UNITED STATES PATENT AND TRADEMARK OFFICE

10/534,776

Office Action Summary

ATTACHMENT A

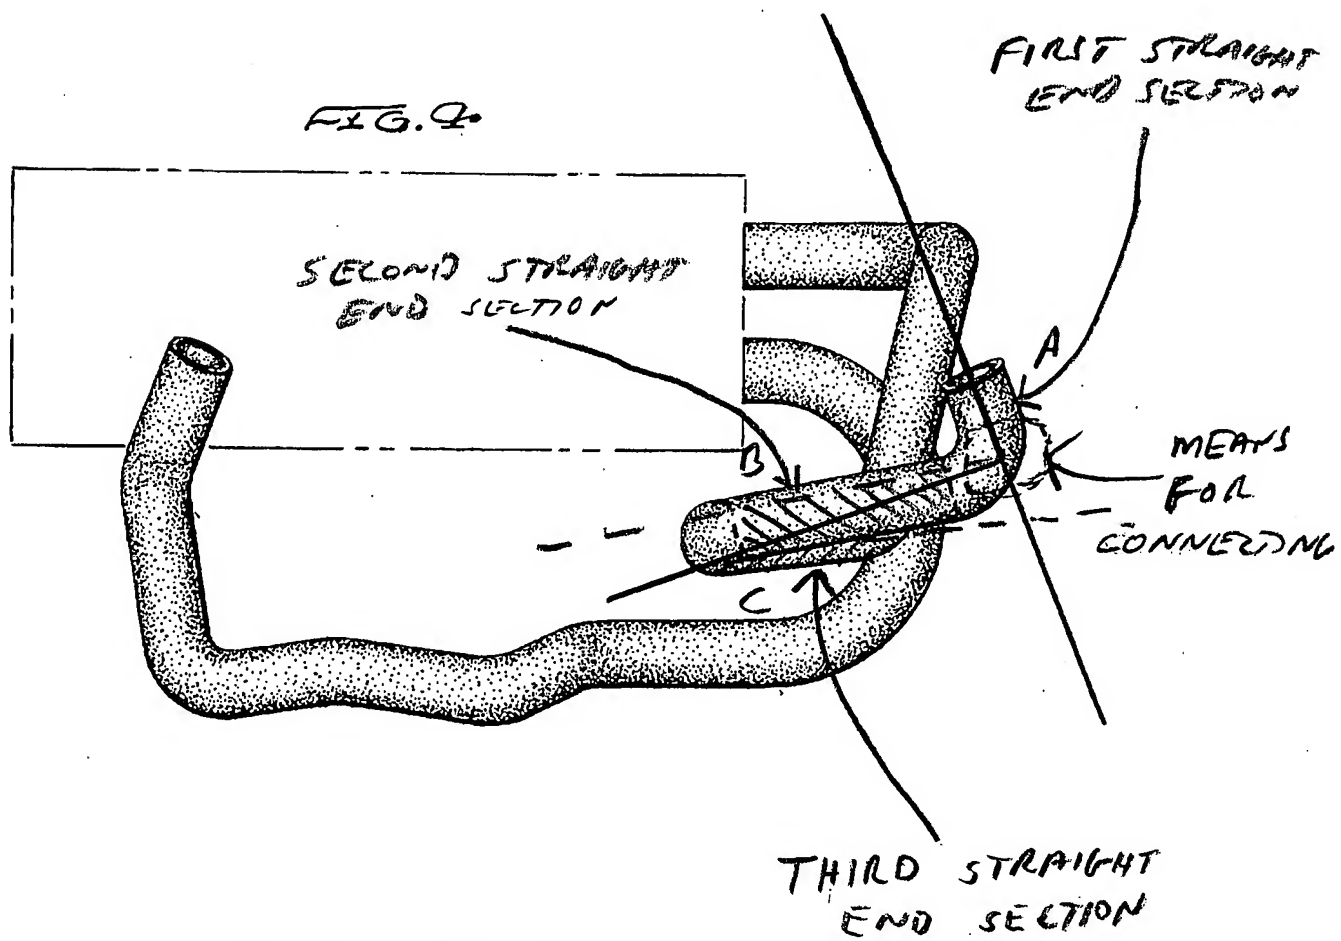
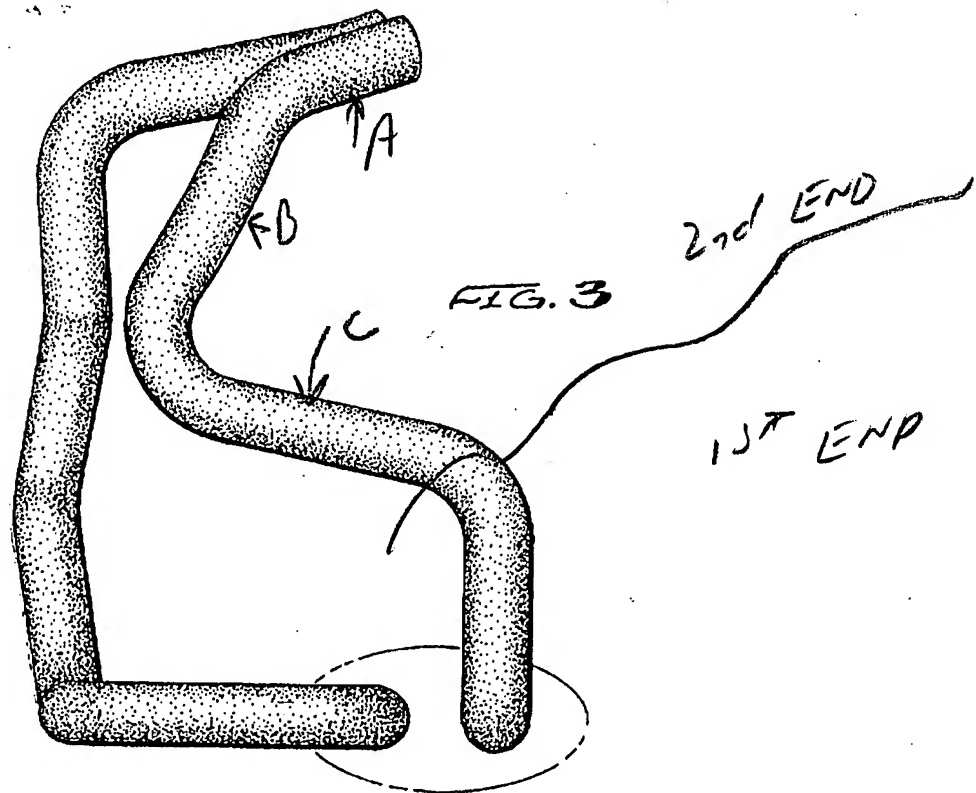
12. In regard to claim 1, Borla discloses in Figures 3 and 4, see Attachments A and B, a fitting, the fitting having a first straight end section (A in Figure 4, see Attachments A and B) positioned along a first centerline and a second straight end section (B in Figure 4, see Attachments A and B) positioned along a second centerline, the included angle between the first centerline and the second centerline differing from a right angle by about 2 degrees \pm ½ degree; wherein the fitting is formed as a single piece.

16. In regard to claim 23, Borla further discloses a third straight end section (C in Figure 4, see Attachment A) positioned along a third centerline, the included angle between the first centerline and the third centerline differing from a right angle by about 2 degrees \pm ½ degree.

17. In regard to claim 24, Borla further discloses that the first straight end portion is connected to the second straight end portion by a curved portion (as observed in Figure 4, see Attachment A) to form a uniform flow path profile.

18. In regard to claim 25, Borla discloses in Figures 3 and 4, see Attachments A and B, a one-piece fitting for tube or pipe, comprising

a first straight end section (A in Figure 4, see Attachment A);

a second straight end section (B in Figure 4, see Attachment A); and

a means for connecting the first straight end section to the second straight end section (as observed in Figure 4, see Attachment A) to form a flow passage that is drainable by gravity when the first straight end section is vertically oriented.

ATTACHMENT B

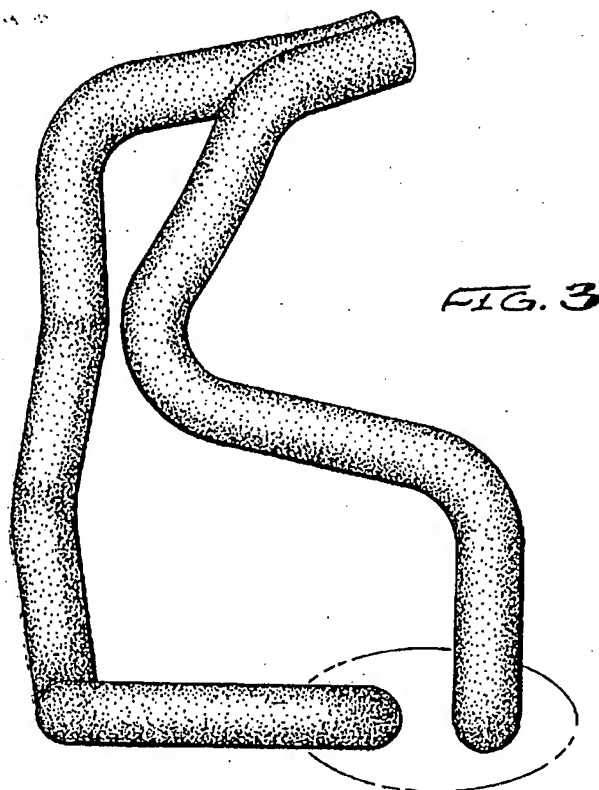
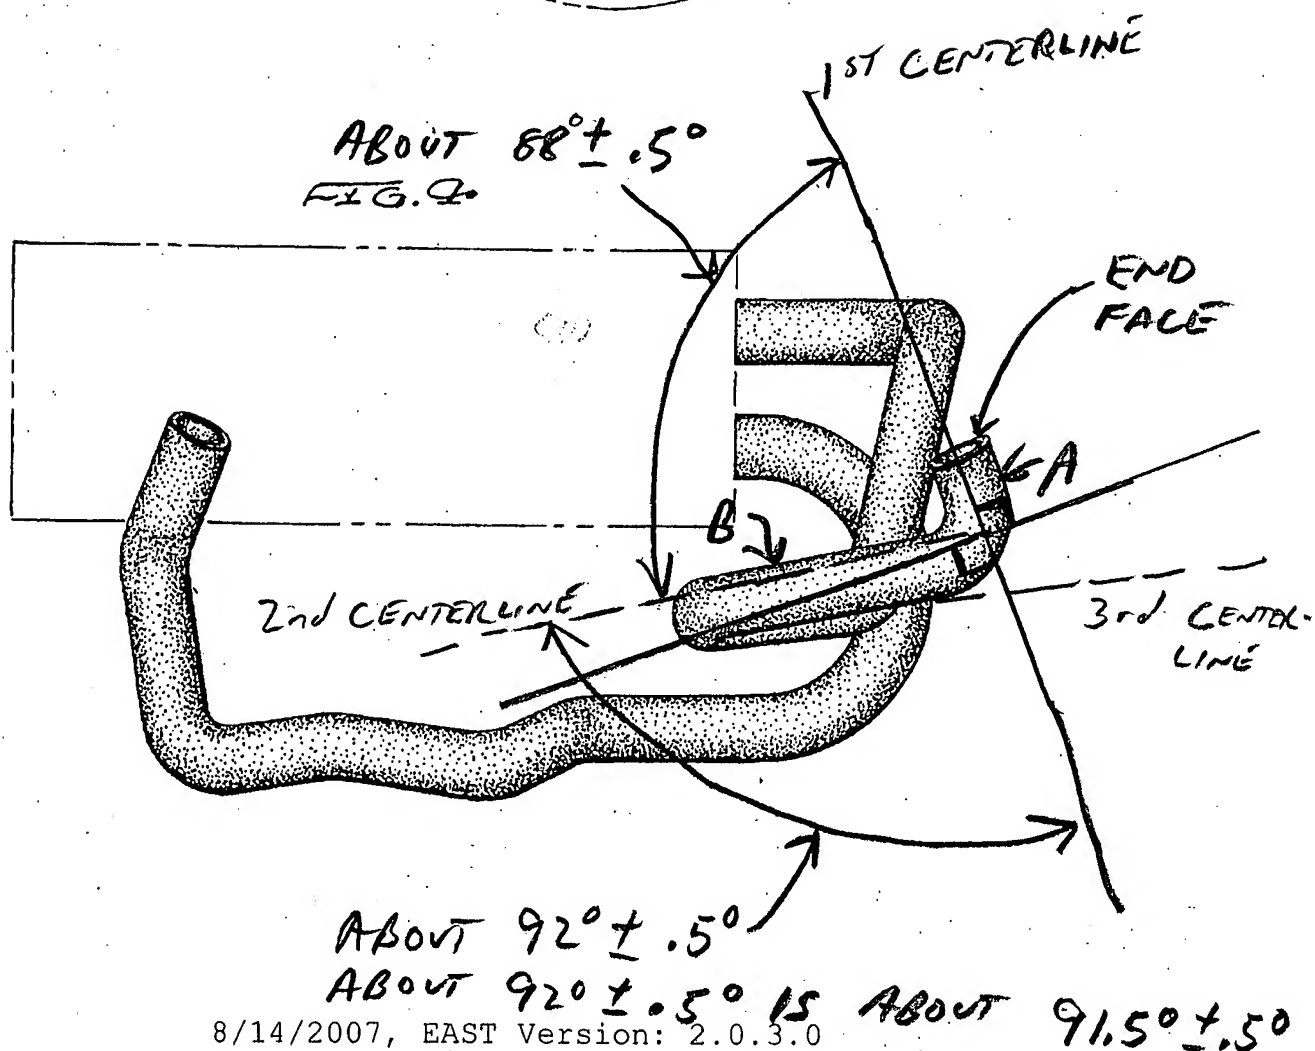
13. In regard to claim 2, Borla further discloses that the included angle is a nominal value of about $88^{\circ} \pm .5^{\circ}$ (as observed in Figure 4, see Attachment B).

14. In regard to claim 3, Borla further discloses that the included angle is a nominal value of about $92^{\circ} \pm .5^{\circ}$ (as observed in Figure 4, see Attachment B).

15. In regard to claim 4, Borla further discloses that at least one of the straight end sections (A in Figure 4, see Attachment B) has an end face that is generally normal to a central longitudinal axis thereof.

19. In regard to claim 26, Borla further discloses that the first straight end section has an end face (as observed in Figure 4, see Attachment B) that extends generally perpendicular to a central longitudinal axis thereof.

20. In regard to claim 28, Borla further discloses that the first straight end section (A as observed in Figure 4, see Attachment B) has a first centerline and the second straight end section (B as observed in Figure 4, see Attachment B) has a second centerline, and wherein the means for connecting (as observed in Figure 4, see Attachment A) the first straight end section to the second straight end section creates an included angle between the first centerline and the second centerline of about $91.5 \text{ degrees} \pm \frac{1}{2} \text{ degree}$. Note that $92 \text{ degrees} \pm .5 \text{ degrees}$ are about $91.5 \text{ degrees} \pm \frac{1}{2} \text{ degrees}$.

ATTACHMENT C

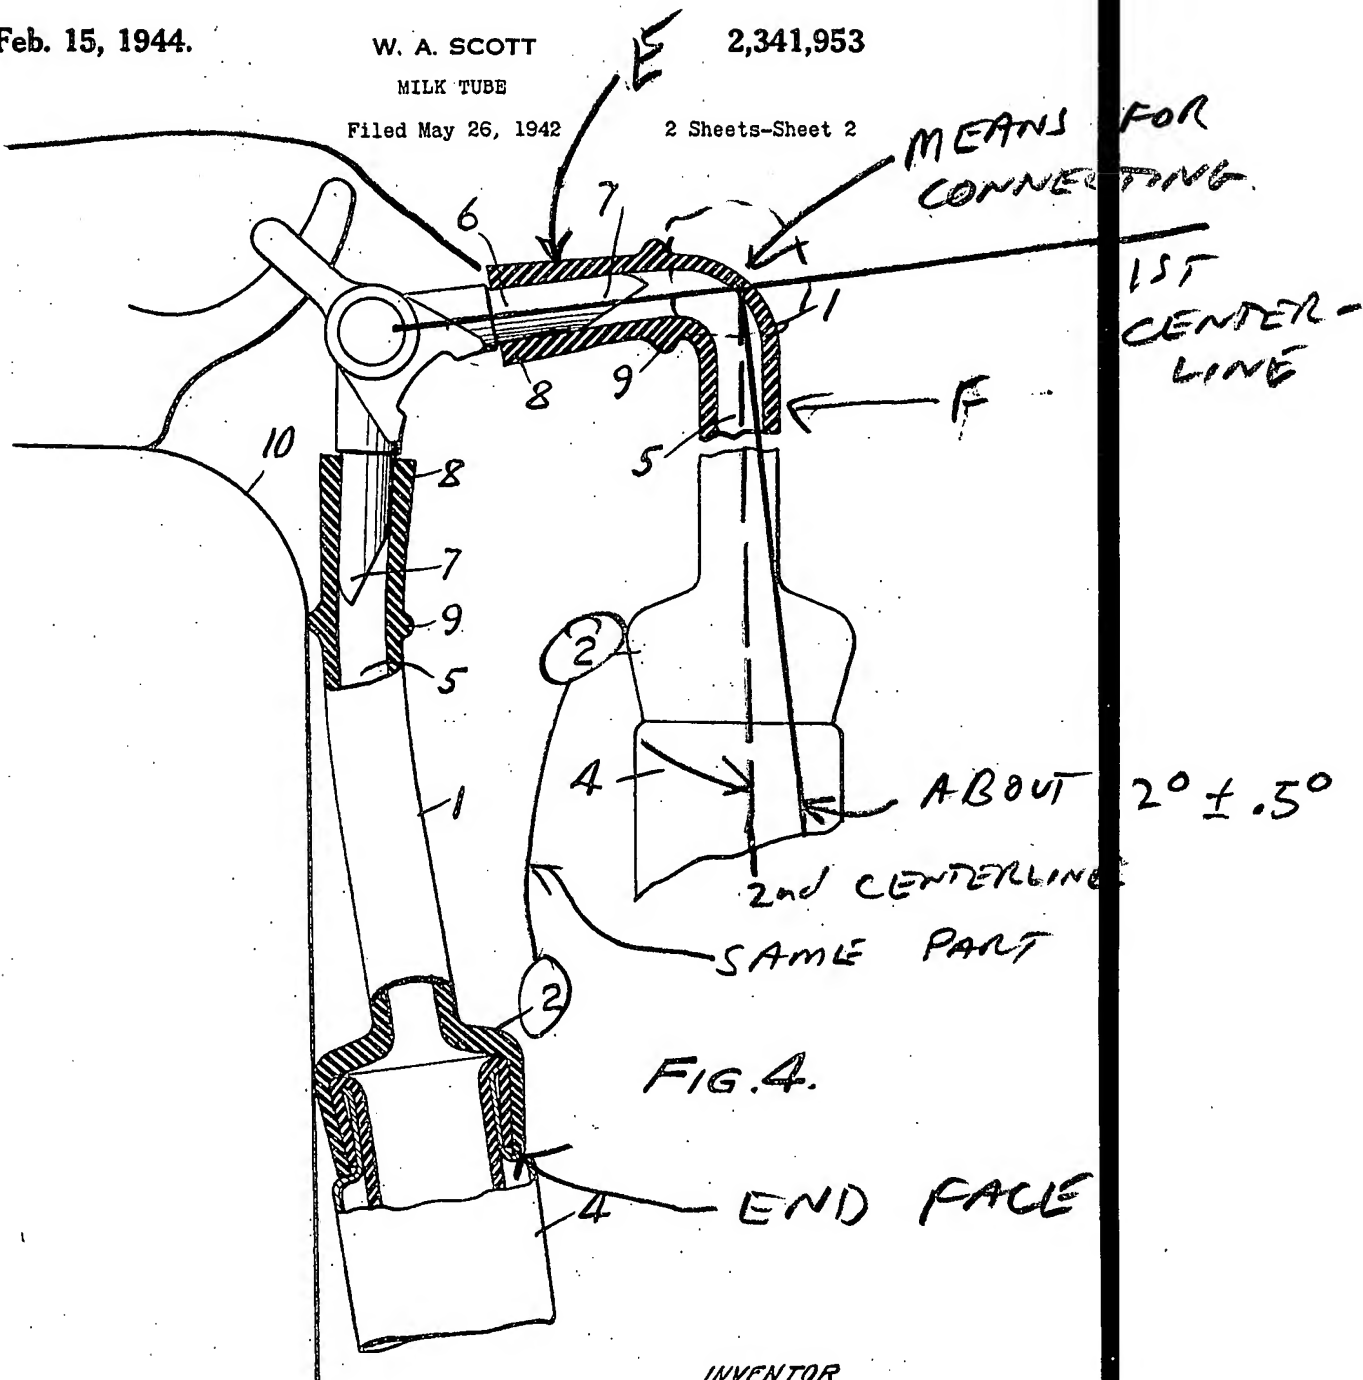
22. In regard to claim 1, Scott discloses in Figure 4, see Attachment C, a fitting, the fitting having a first straight end section (E in Figure 4, see Attachment C) positioned along a first

centerline and a second straight end section (F in Figure 4, see Attachment C) positioned along a second centerline, the included angle between the first centerline and the second centerline differing from a right angle by about 2 degrees \pm ½ degree;

23. In regard to claim 5, Scott further discloses each of the straight end sections has a respective end face (as observed in Figure 4, see Attachment C) that is generally normal to a central longitudinal axis thereof.

24. In regard to claim 25, Scott discloses a one-piece fitting, comprising
a first straight end section (E in Figure 4, see Attachment C);
a second straight end section (F in Figure 4, see Attachment C); and
a means for connecting the first straight end section to the second straight end section (as observed in Figure 4, see Attachment C) to form a flow passage that is drainable by gravity when the first straight end section is vertically oriented.

25. In regard to claim 27, Scott further discloses that each of the straight end sections (E and F as observed in Figure 4, see Attachment C) has a respective end face (as observed in Figure 4, see Attachment C) that extends generally perpendicular to a central longitudinal axis thereof.
